Re: PER Drainage design review

EA has reviewed the latest drainage design and calculations for the PER property sent to EA on October 22. EA concurs with the submitted calculations and approach to manage the 100-year runoff from the 3975 Elm Avenue property. However, the pre- versus post-development ponding conditions have still not been quantified along the 3975 Elm Avenue/PER property line to show improvements to drainage conditions (see #4 below). The storm drain plan view layout has not changed since the last submittal but the storm drain pipe sizes have been increased and the pipe inverts have generally been lowered to decrease the water surface elevations in the system during the 100-year rainfall event. Additionally, a TideFlex valve has been added to the outfall of the storm drain system which conveys water from the 3975 Elm Avenue property. The following are EA comments provided to you on October 2 (in black) followed by EA's observations of the revised October 22 submission in red:

POST DEVELOPMENT DRAINAGE MAP
PORTSMOUTH TERMINAL FACILITY

GRADING PLAN AND UTILITY PLAN
PORTSMOUTH TERMINAL FACILITY

SECTION A-A

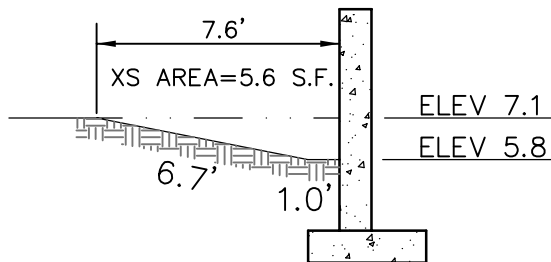
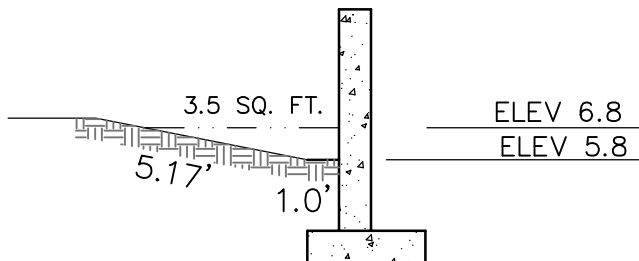
3. Once the HGLs are corrected, it will be important to check the HGL at each manhole/flushed end section (FES) along the PER/3975 Elm Avenue property line to make sure water is not ponding along the proposed retaining wall. As a suggestion, it appears that the storm drain could be lowered to accommodate total capture of runoff from the 3975 Elm Avenue property with no backup. See attached "property line" pdf for concept. Please provide similar cross sections at critical points along the retaining wall for review (especially at STMH-4). Mr. (b) (6) is concerned with additional flow/velocity along the 3975 Elm Avenue property undercutting the existing concrete pad on his property. A cross section with HGL shown (similar to the attached pdf) may ease those concerns.

4. Pete met with Mr. (b) (6) on 9/24 to discuss drainage patterns of the 3975 Elm Avenue property. Attached is an annotated C2 sheet indicating the drainage patterns on the property as described by Mr. (b) (6) and as confirmed during the visit. EA strongly suggests using similar drainage area delineations to the attached annotations to demonstrate to Mr. (b) (6) that his concerns have been addressed. Also, Mr. (b) (6) is very concerned about the capacity of the ditch between the PER property and his, and he is also very concerned about maintaining positive drainage from this area in the pipe along the swale alignment you are proposing. EA strongly suggests that you perform a pre-development conditions analysis to demonstrate that the proposed PER development will improve the drainage along the PER/3975 Elm Avenue property boundary in the post-development condition. This could be demonstrated through improved water surface elevations and lack of ponding in the ditch between the two properties.

$$Q = 1.486/N \times A \times R^{0.67} \times S^{0.50} = 1.05 \text{ CFS AT FULL DEPTH OF 1.3'}$$

WATER DEPTH OF WATER=12": (ELEV 6.80)

6.80 > 6.67; CONTROLLING ELEV=6.80

CONCLUSION:

THE 100 YEAR STORM ON A PRE DEVELOPED CONDITION IS NOT CONTAINED IN THE EX. DITCH SECTION AND WILL REACH A MIN. ELEVATION OF 7.1 (TOP OF DITCH BANK); SINCE WATER IS REMOVED FROM THE DITCH VIA ONSITE GRADING AND WITH THE ADDITION OF A FES AT STMH-1, THE WATER SURFACE PROFILE ELEVATION IS LOWER AT POST DEVELOPED CONDITIONS.
